Project: SE Polk CSD Four Mile Elementary Lighting Replacement Project Number: 25-175 Date: March 26, 2026

Note { *This addendum has been issued to modify and/or interpret the bidding documents, including the drawings and specifications. Unless otherwise instructed, the information contained on the addendum shall take precedence over anything contrary on the original bidding documents and shall be hereinafter considered as a part of the bidding documents.*

VERSION	100% CONSTRUCTION DOCUMENTS
DATE	03/23/2024
SHEET NAME:	DEMOLITION PLAN - AREA A
SHEET:	ED1.1

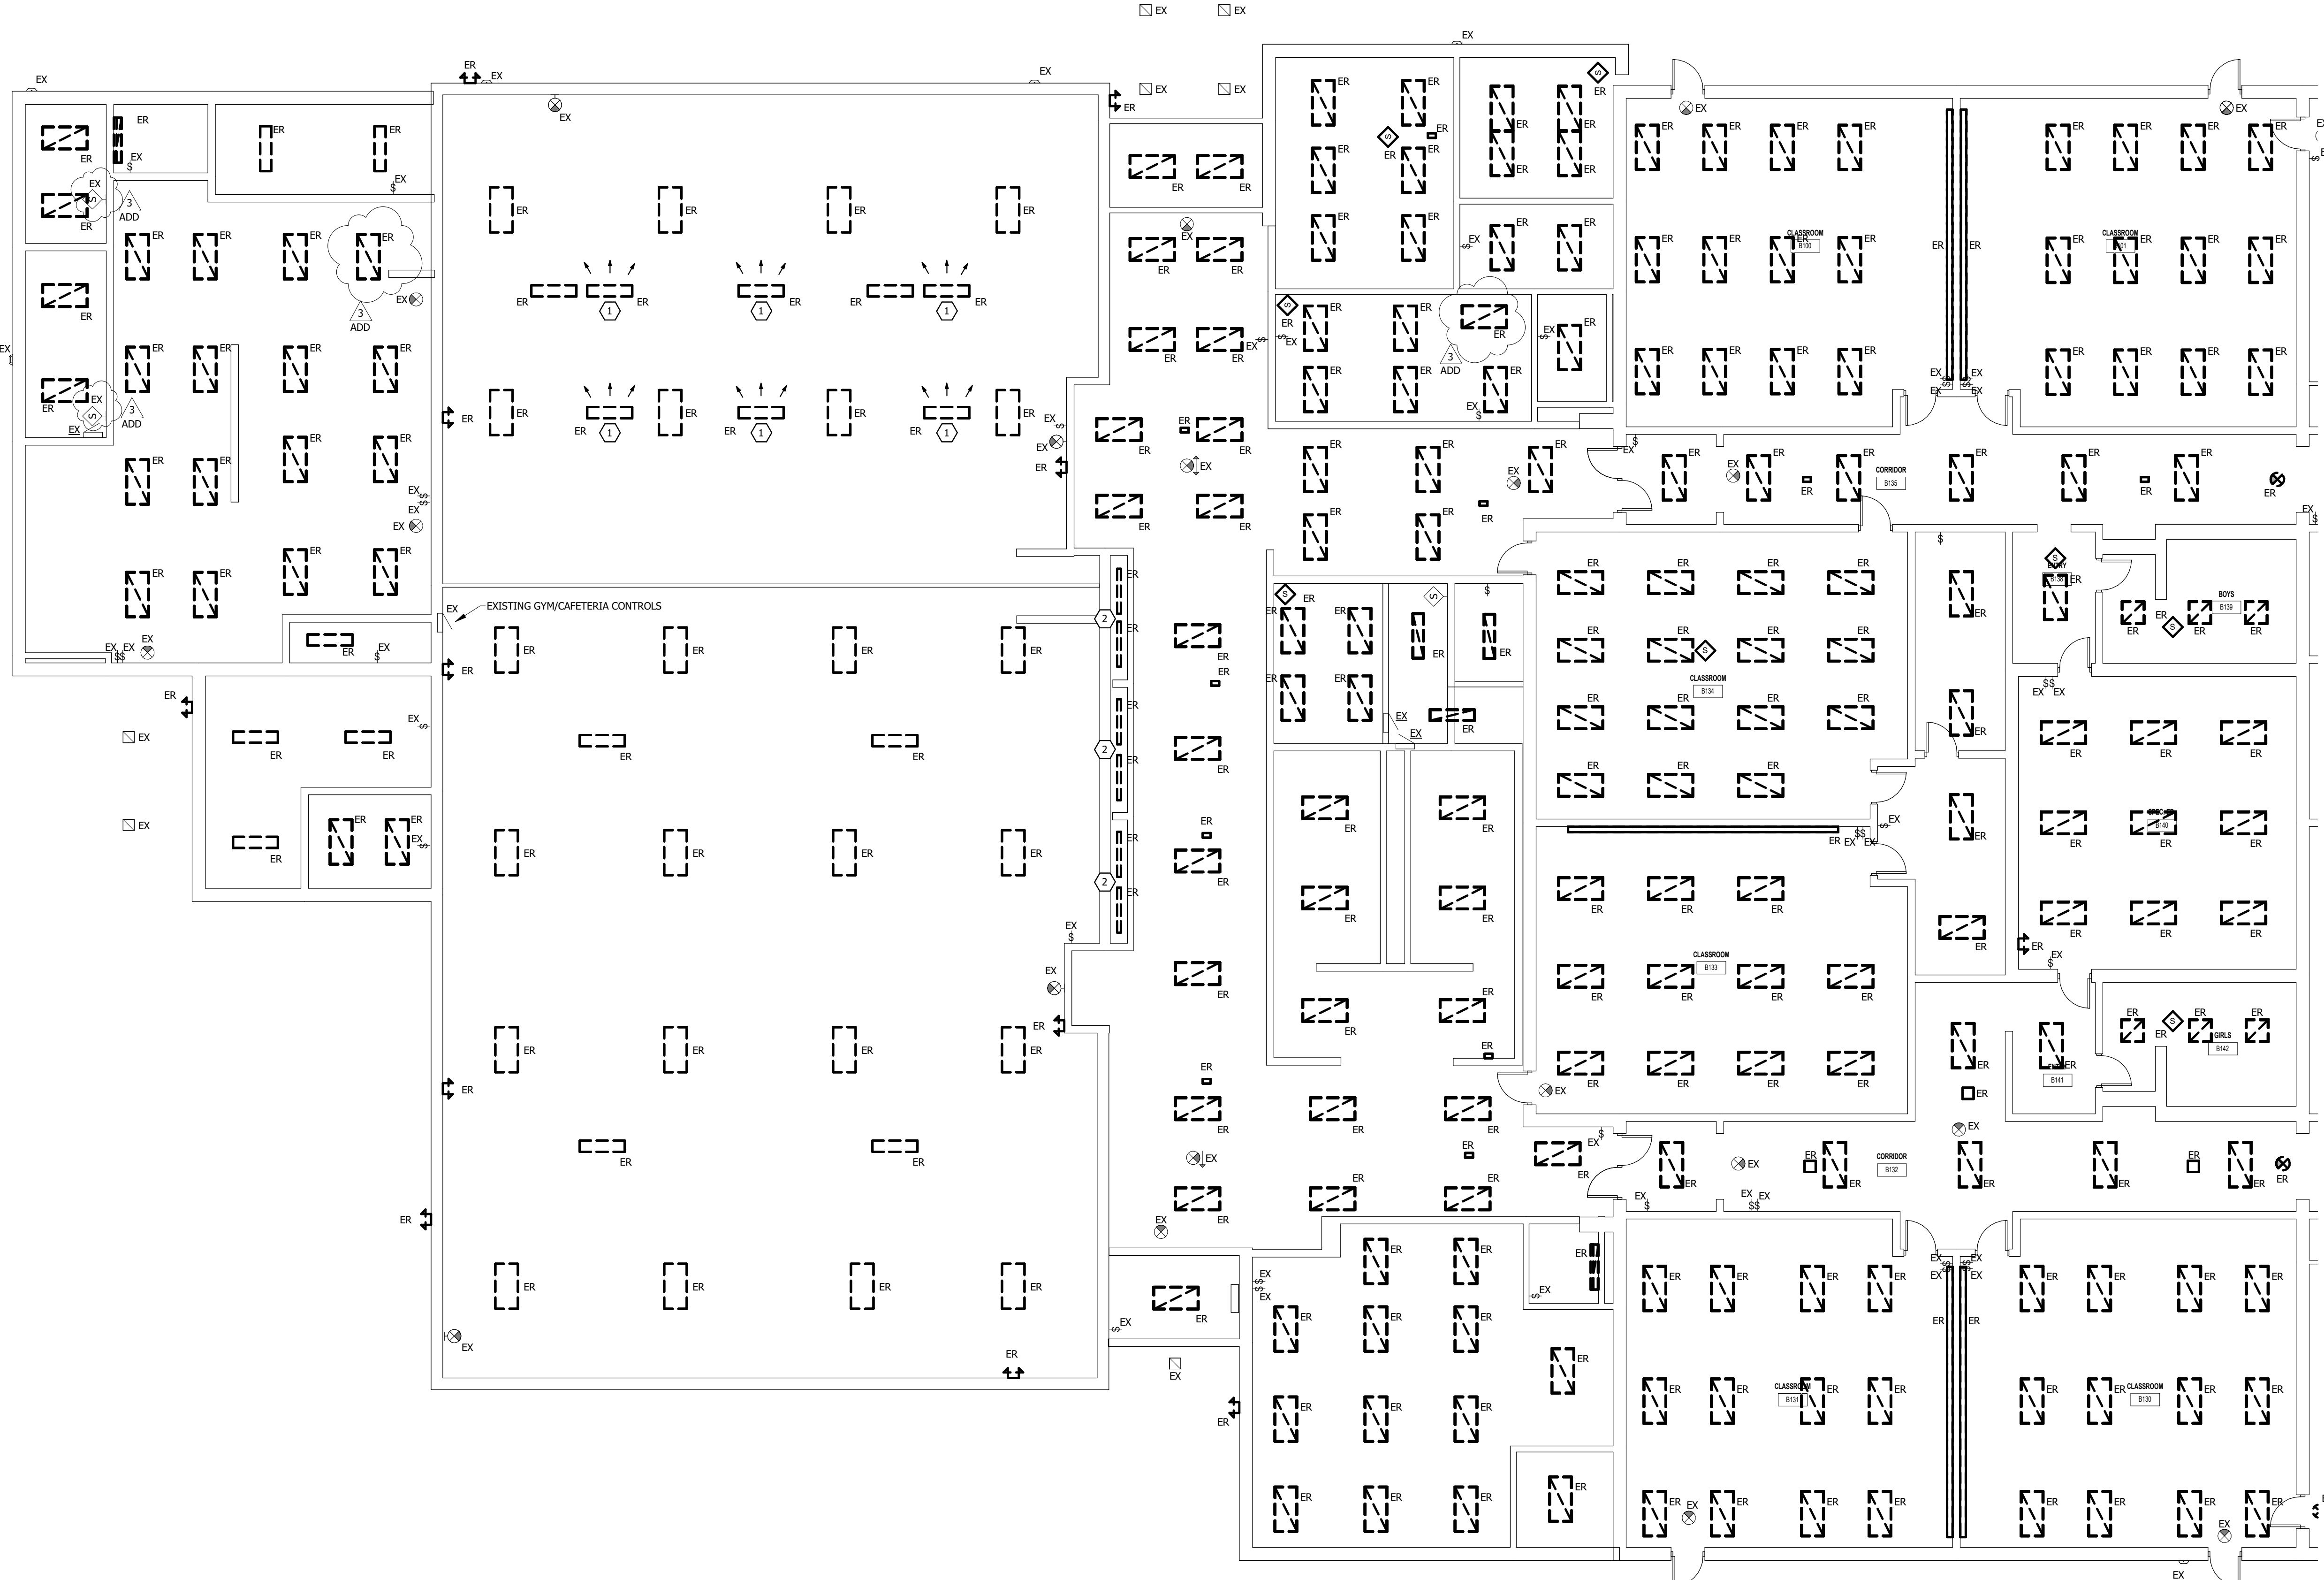
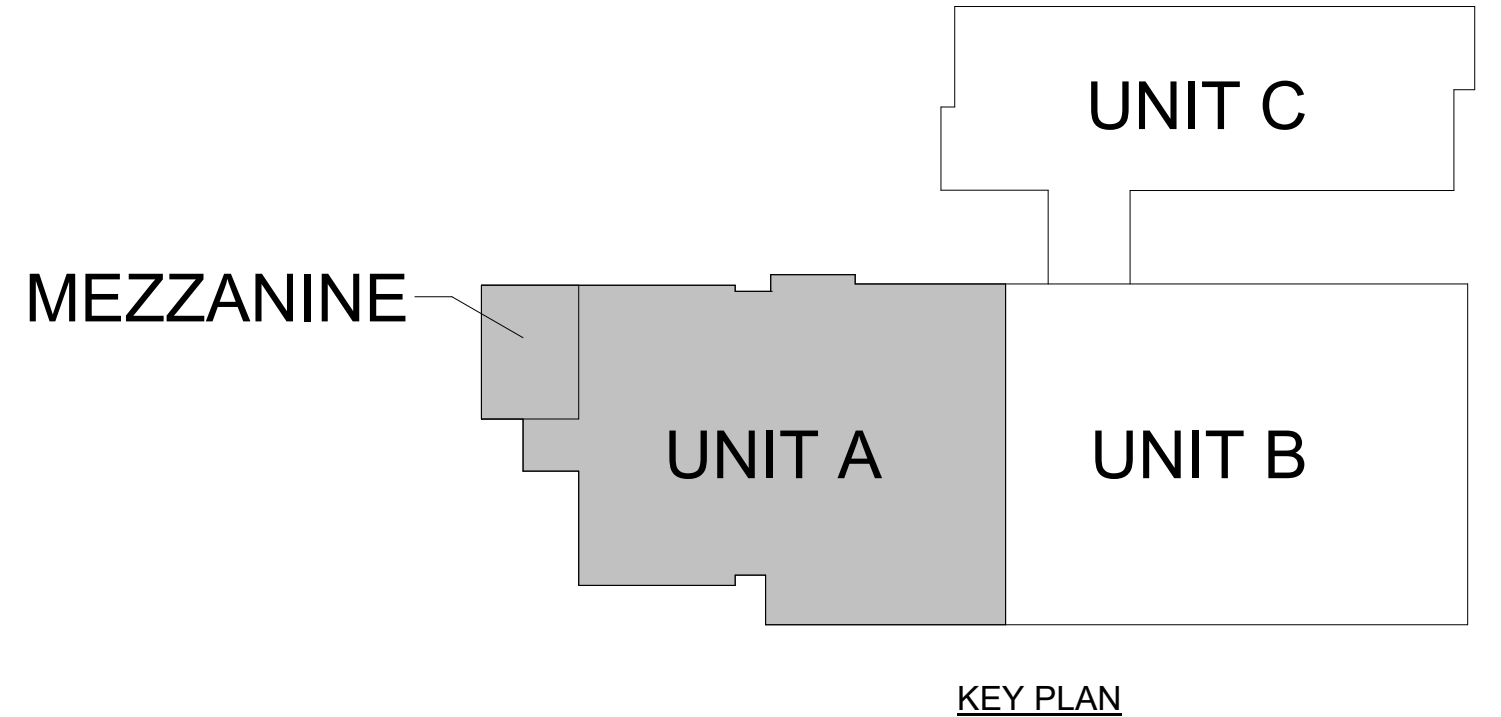
1. **REVISE** existing switches to be occupancy sensor wall switches as shown on the attached sheet.
2. **ADD** existing 2x4 troffer to be removed as shown in the kitchen on the attached sheet.
3. **REVISE** orientation of existing 2x4 troffer in nurse’s office as shown on the attached sheet.
4. **REVISE** bolded scope note to include fixture type PC-X under alternate scope.

VERSION	100% CONSTRUCTION DOCUMENTS
DATE	03/28/2008
SHEET NAME:	DEMOLITION PLAN - AREA B
SHEET:	ED1.2

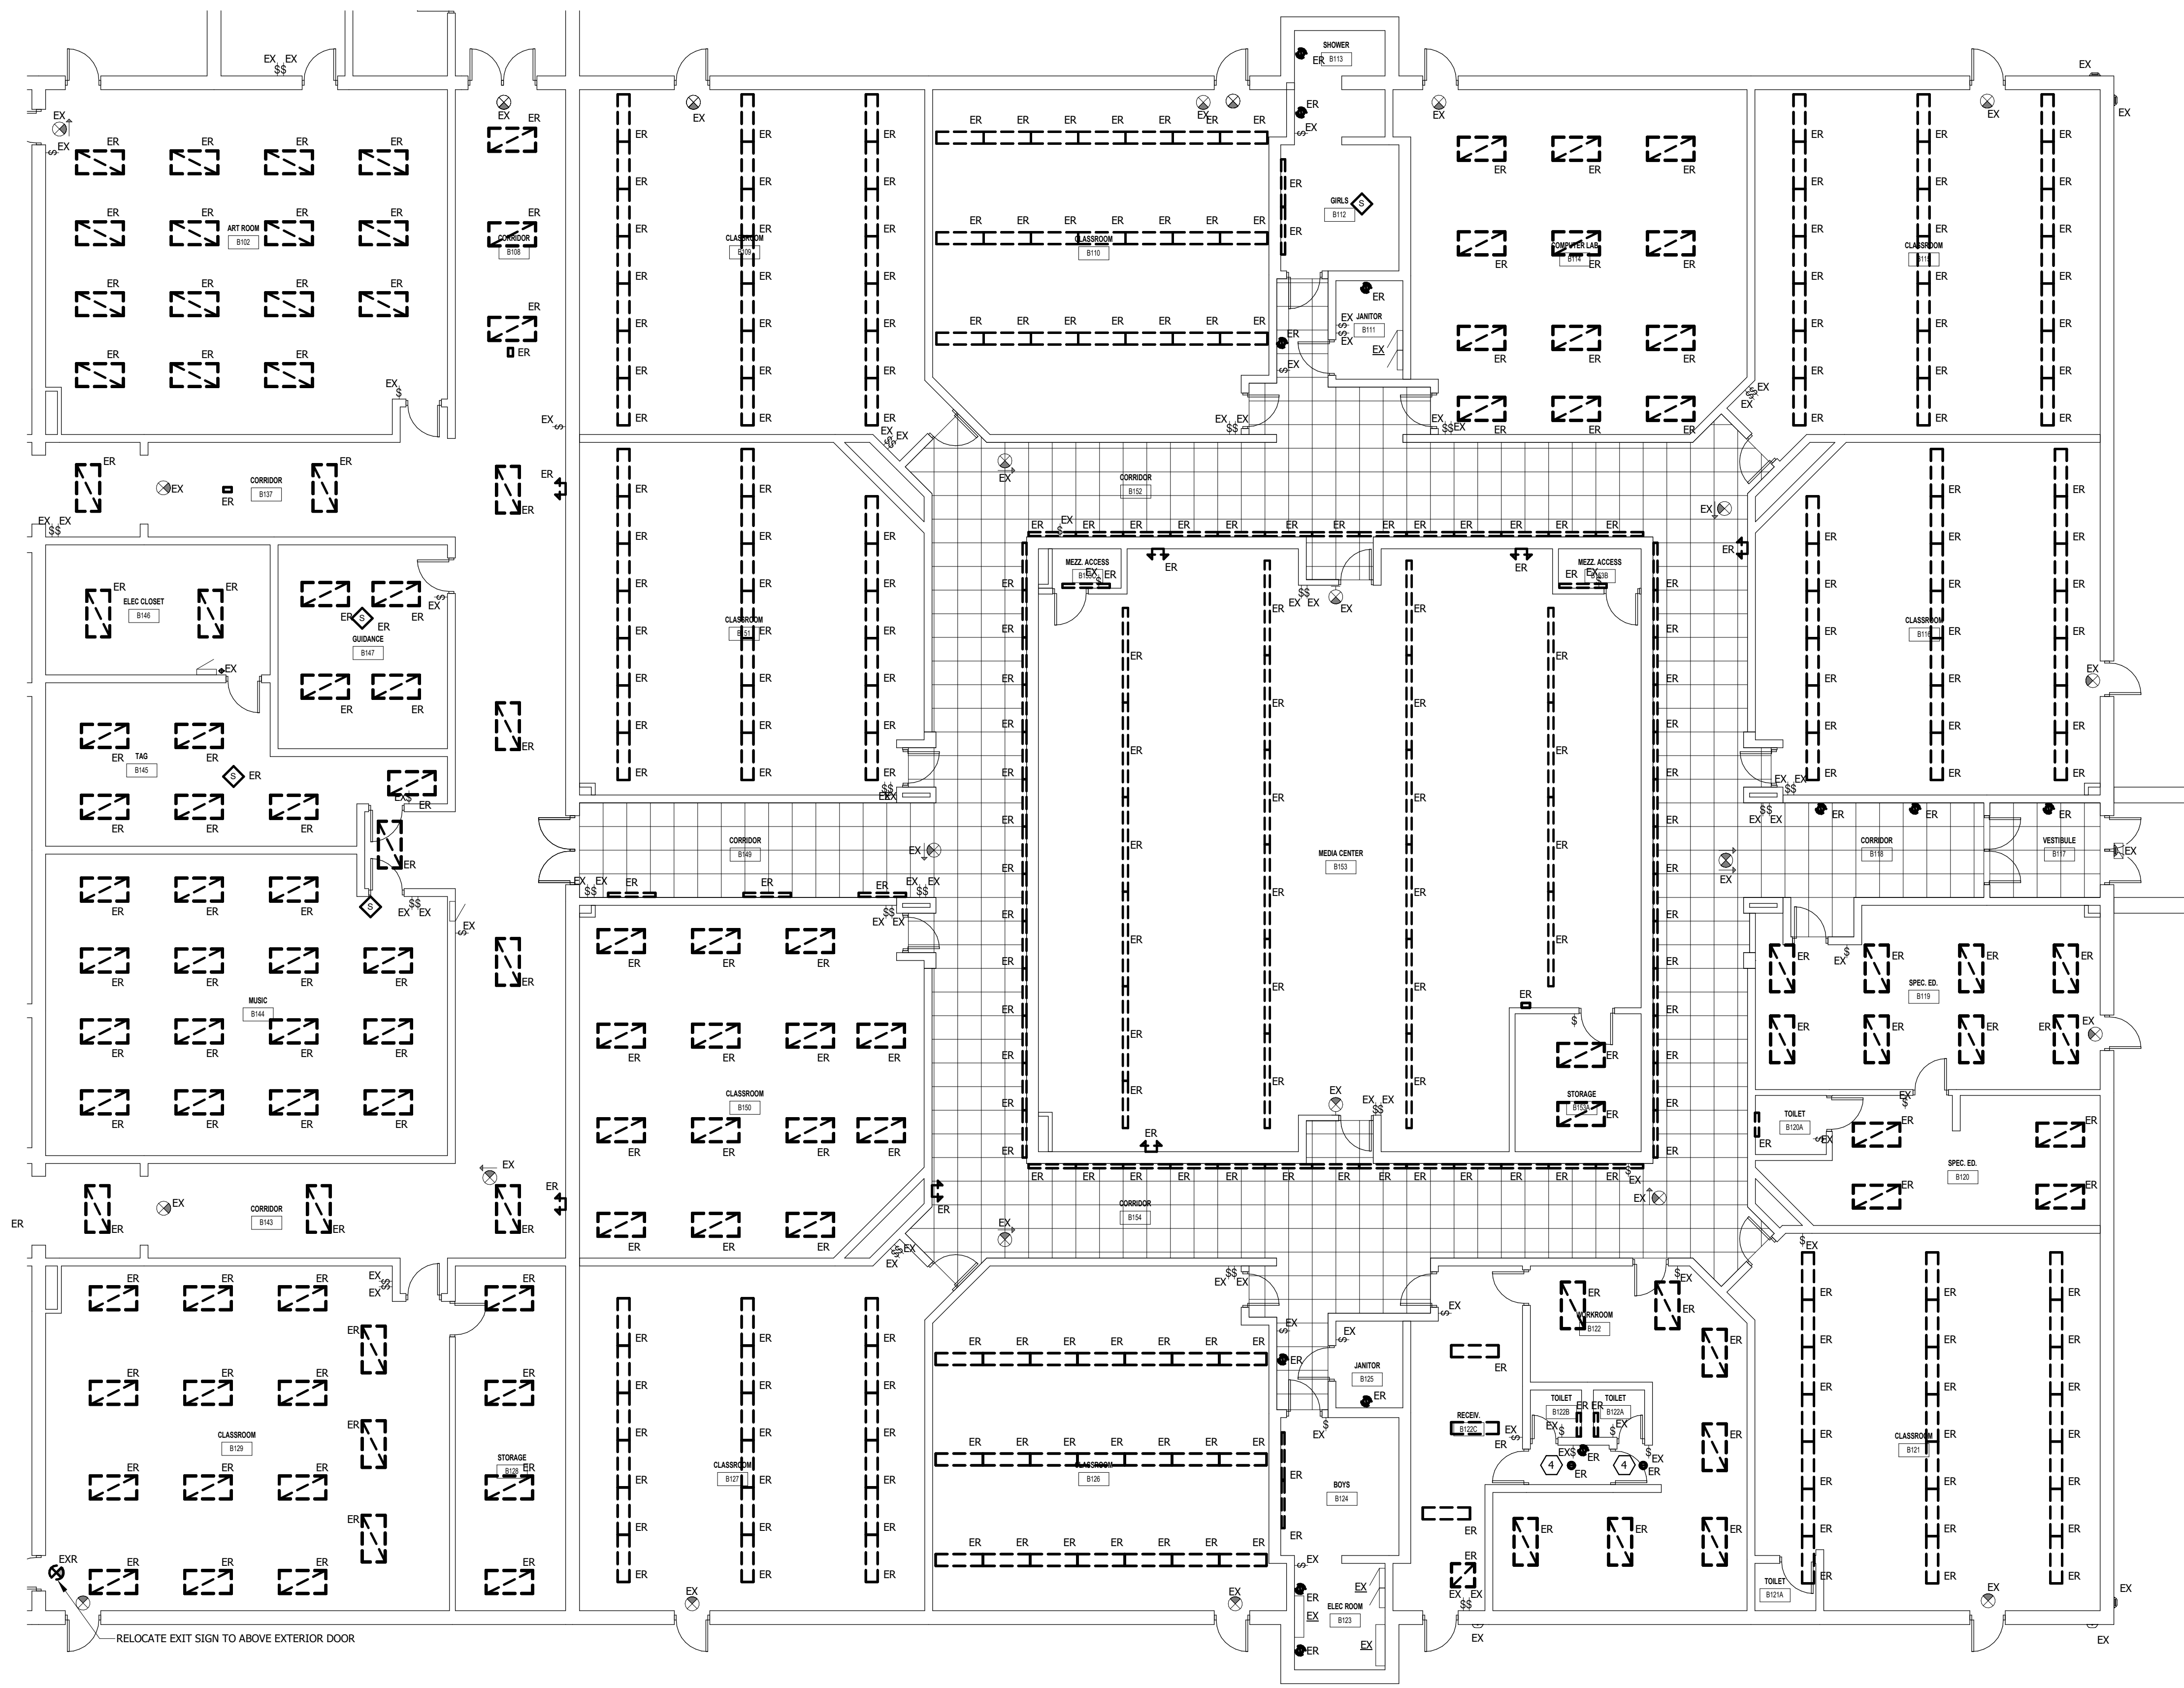
1. **REVISE** bolded scope note to include fixture type PC-X under alternate scope.
